SPECIAL MANAGEMENT AREA ORDINANCE
CHAPTER 25, ROH
Environmental Assessment (EA)/Determination
Finding of No Significant Impact

DEPT. OF PLANNING
**(Hale'iwa & Ali'i Beach Park
Bathhouse)**
HALE'IWA, O'AHU

Project:	Hale'iwa Ali'i Beach Park Bathhouse and Related Improvements
Proposing Agency:	City & County of Honolulu Department of Design and Construction 650 South King Street, 9 th Floor Honolulu, Hawai'i 96813 Contact: Wesley Obata, 523-4783
Approving Agency:	City & County of Honolulu Department of Planning and Permitting 650 South King Street, 7 th Floor Honolulu, Hawai'i, 96813 Contact: Artis Shaw, 527-5349
Location:	Hale'iwa Ali'i Beach Park, 105 Hale'iwa Road Hale'iwa, City and County of Honolulu, O'ahu, Hawai'i
Proposed Action:	Construction of Bathhouse, Parking, and Outdoor Shower
Tax Map Key:	6-6-002:001
Parcel Land Area:	19.245 acres
Landowner	City & County of Honolulu
Present Use:	Park
State Land Use District:	Urban
Development Plan Land Use Designation:	Parks & Recreation
Present Zoning:	P-2 General
Special Management Area:	Yes
Anticipated Determination:	Finding of No Significant Impact

FIGURE 1-2:

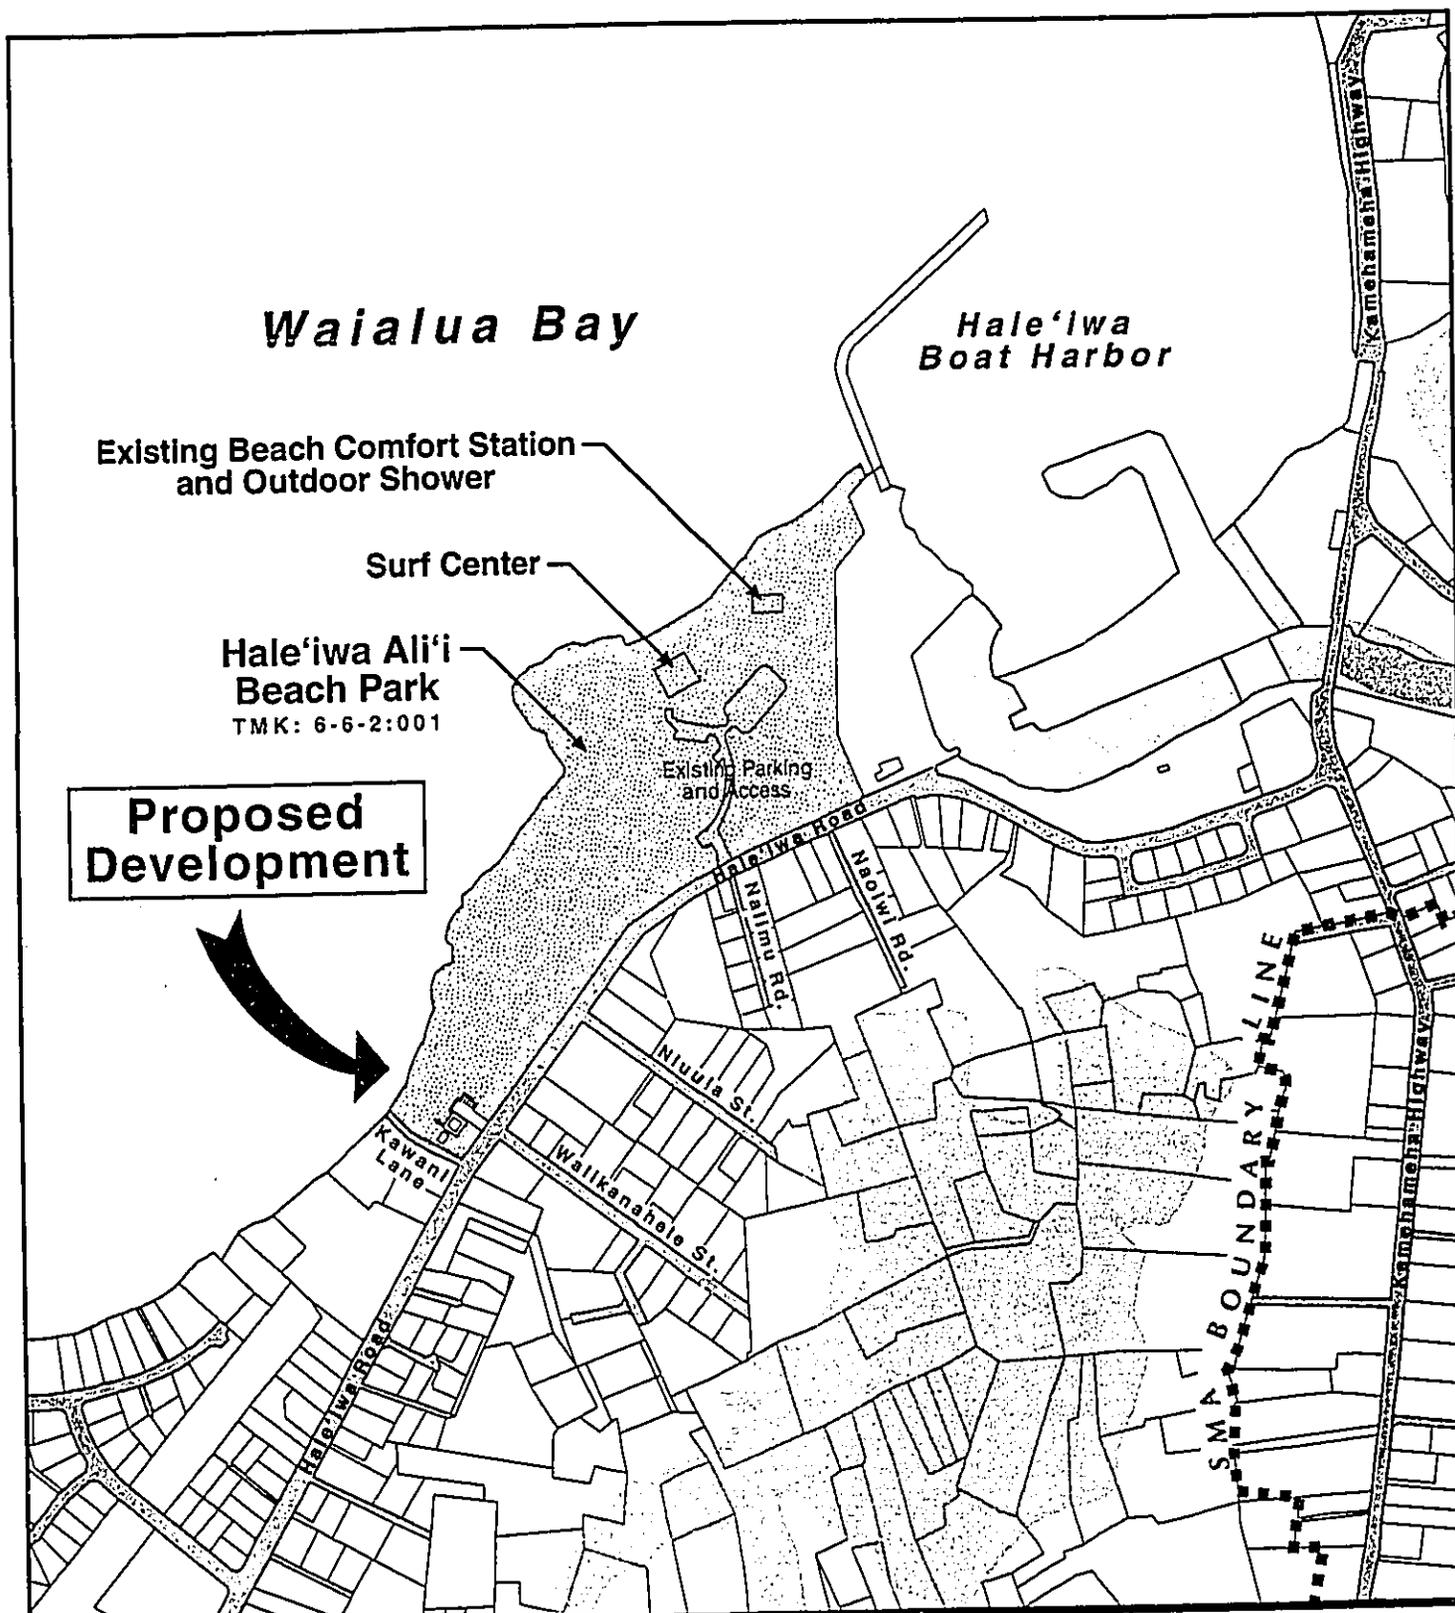
(2) Show where the existing park parking area and access is located.

The Park currently is used for two distinct purposes. First, it is a recreational center for public park and beach users. Second, it is used commercially for the production of the Baywatch television series. Most existing activity is concentrated at the Park's northeastern end. The existing parking area is located there and is reached via Hale'iwa Road. The area that would be occupied by the proposed bathhouse presently consists of an open lawn (see Figure 1-2).

In addition, the location of the existing park entrance and parking area has been added to Figure 1-2 in the Final EA.

FIGURE 1-3:

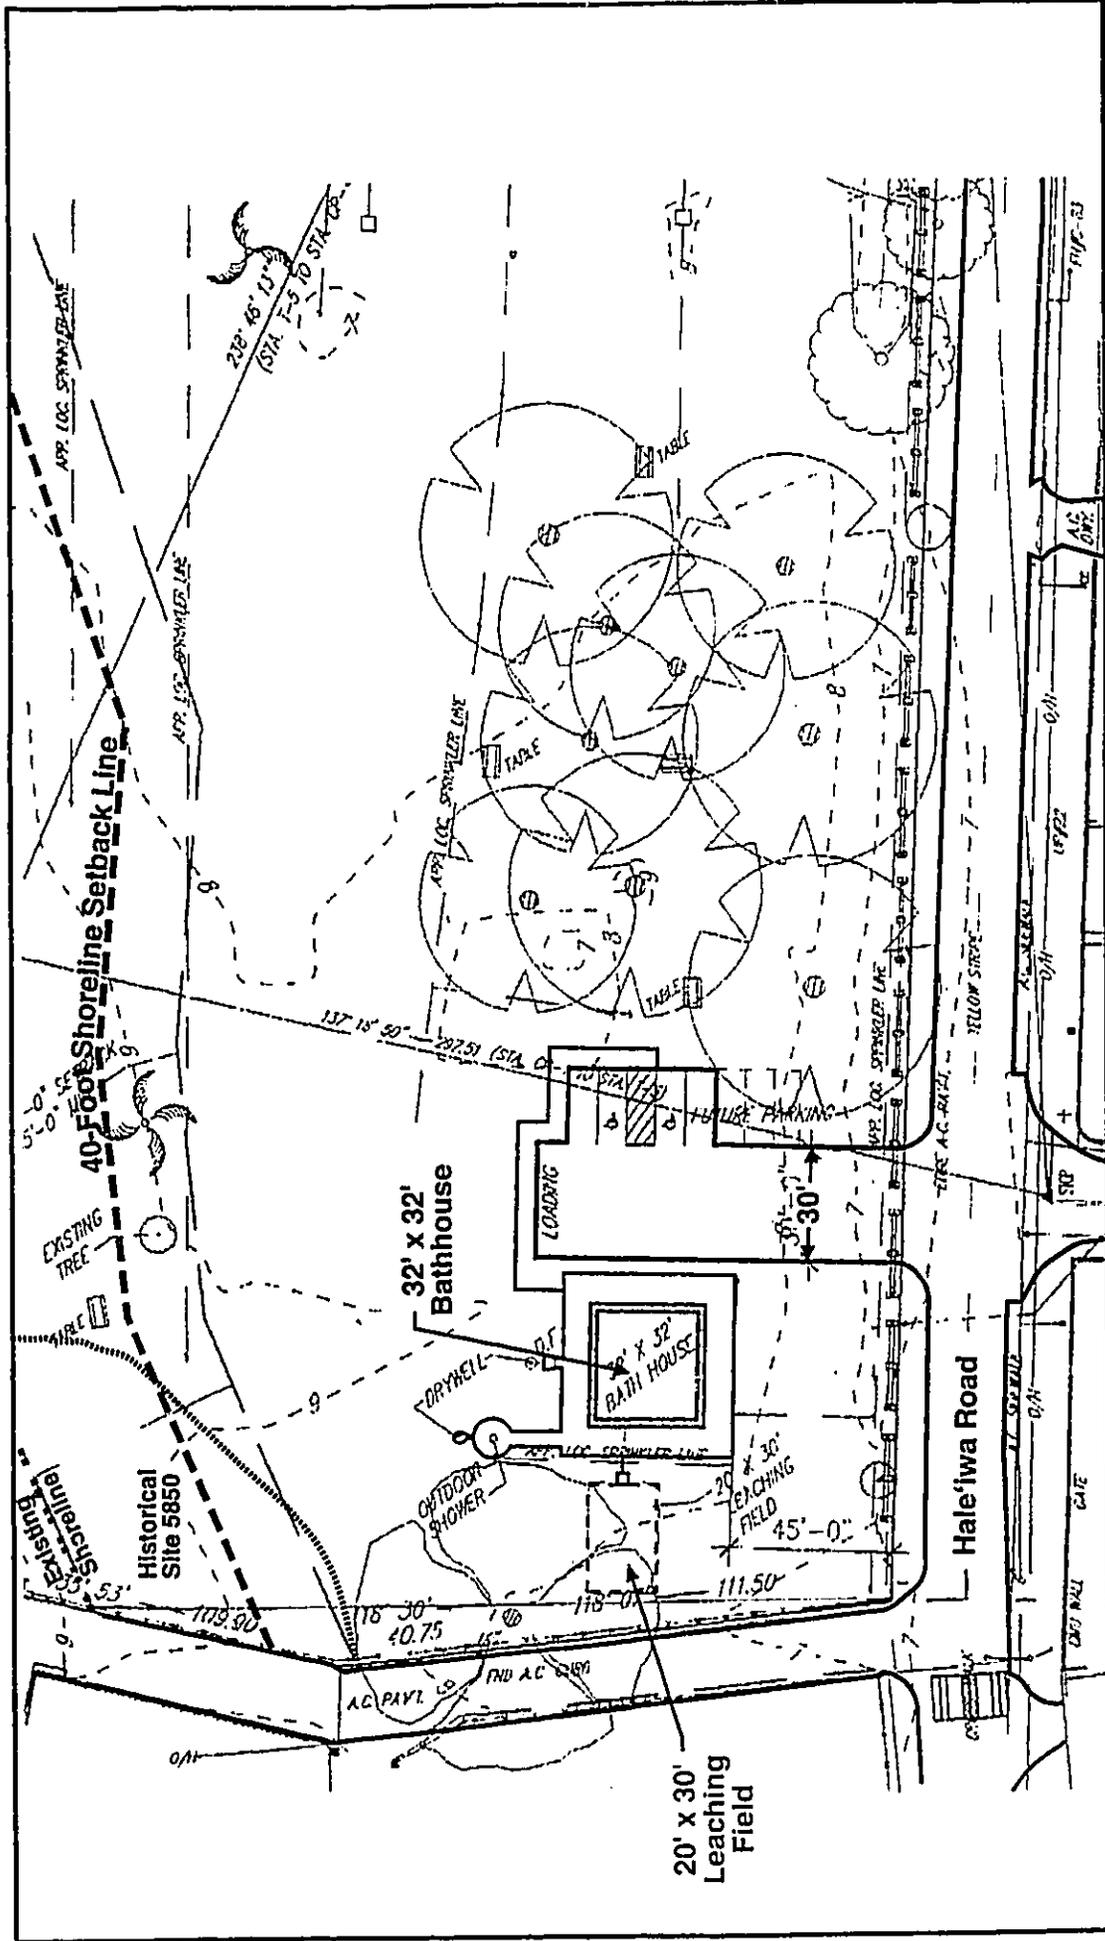
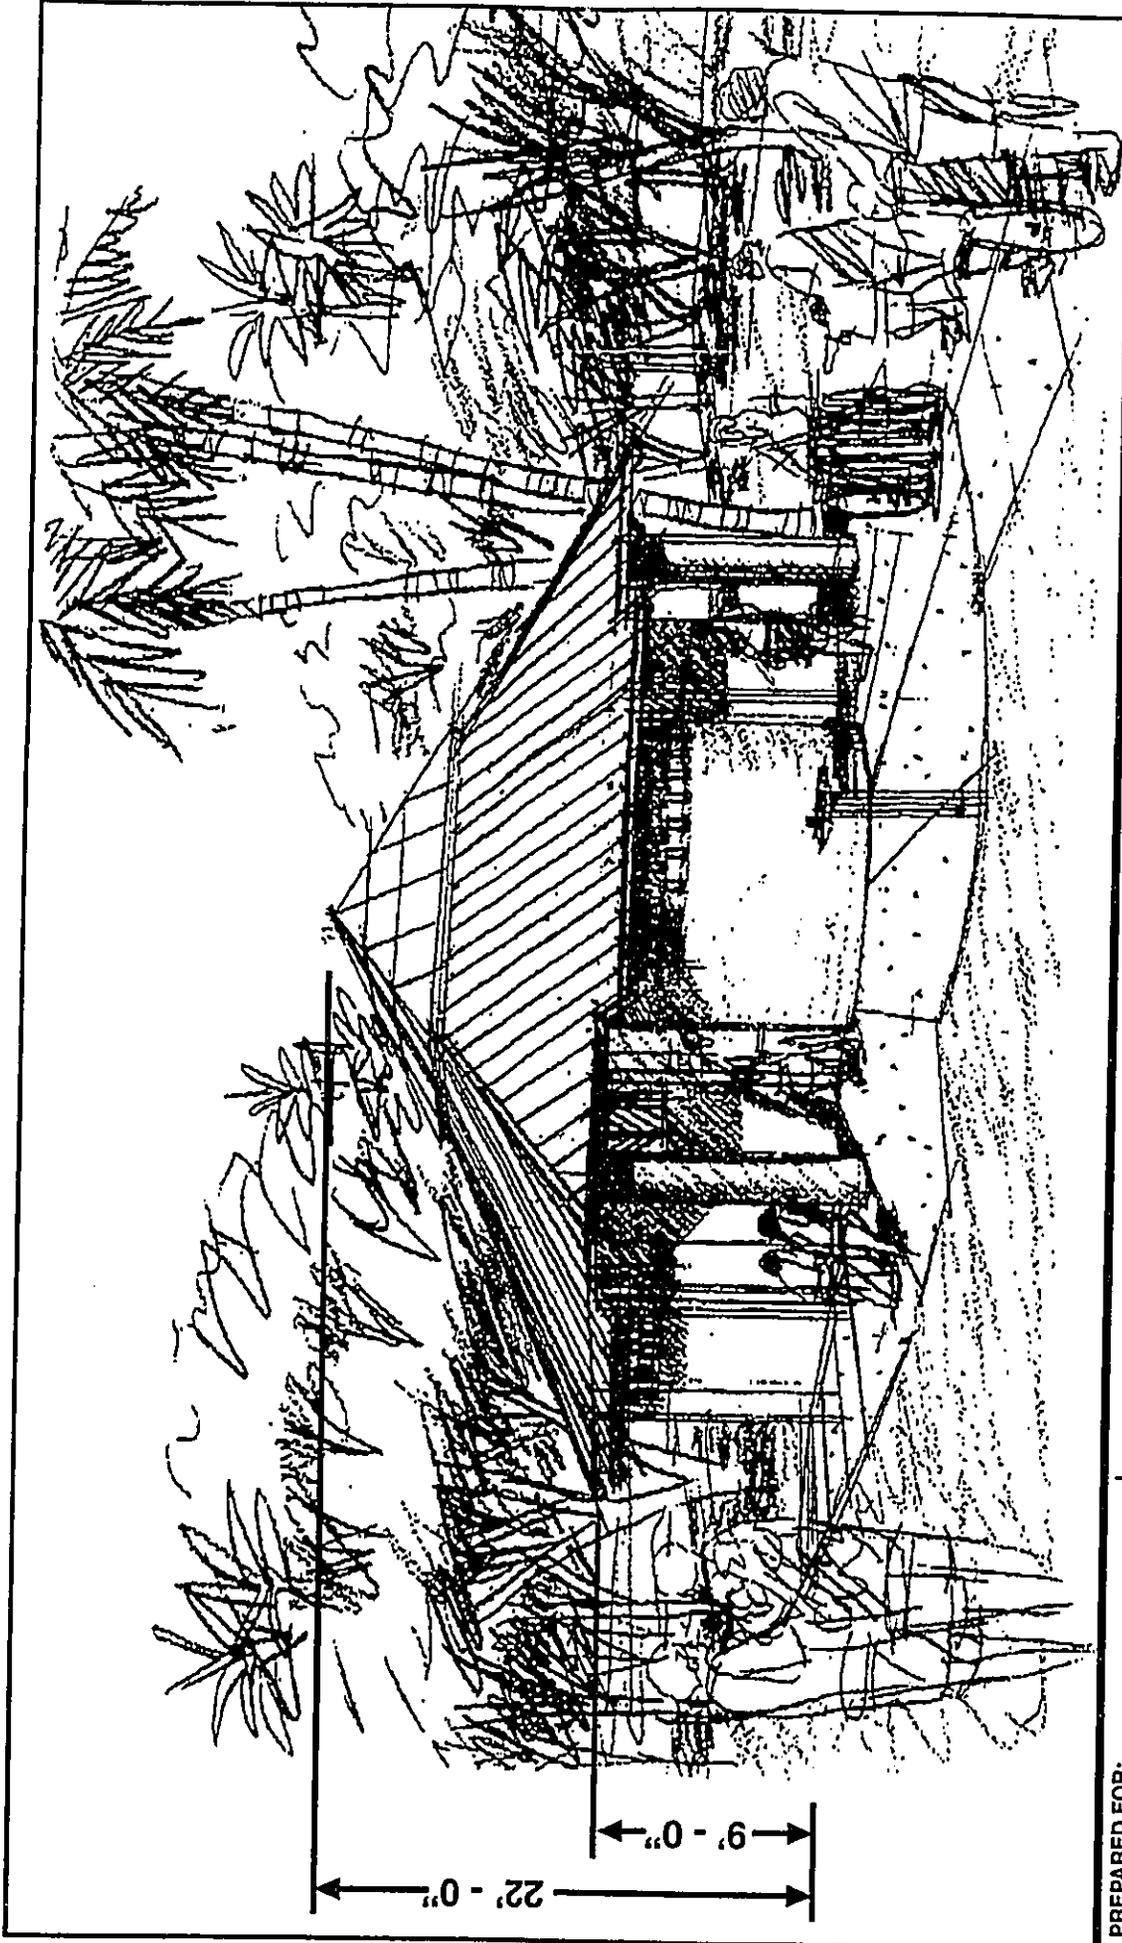
Your specific concern, related to the preservation of historical site 50-80-04-5850, is being accommodated by re-location of the bathhouse and implementation of a specific preservation plan. Figure 1-3 of the Final EA, copy attached, has been modified to show the new location of the bathhouse. Section 2.1.7.1 of the EA has been modified as follows:

1. Indicate whether additional landscaping is proposed around the bathroom and parking area.
2. Show where the existing park parking area and access is located.
3. State whether there are existing land forms in the area and if the proposed improvements will alter the land forms.
4. Describe the existing on-site storm drainage system and how the system avoids an increase in the volume of storm water runoff.
5. How is the existing solid waste disposed of and will the proposed improvements increase the amount of solid waste?
6. Where will the runoff from the outdoor shower and parking area drain?
7. Discuss how the project complies with Chapter 23, ROH, Shoreline Setbacks and show the 40-foot shoreline setback on the exhibits.

(7) Discuss how the project complies with Chapter 23, ROH, Shoreline Setbacks and show the 40-foot shoreline setback on the exhibits.

Readers should note that the exact positioning of the bathhouse, parking area, and shower as shown in Figure 1-3 differs slightly from that shown in *Draft EA*. The modifications were made in response to results of archaeological field surveys that were not available at the time the earlier document was prepared and in accordance with recommendations made by the State Historic Preservation Division. These findings are discussed in Section 2.1.7.

The proposed facilities are located outside the 40-foot setback area. This has been clarified by depicting the 40-foot setback line on Figure 1-3 and by adding the following as the third paragraph in Section 5.1.

As shown in Figure 1-3, the proposed facilities are more than 40-feet inland of the shoreline. Consequently, their construction will not require a Shoreline Setback Variance in accordance with the Revised Ordinances of Honolulu (ROH), Section 23.
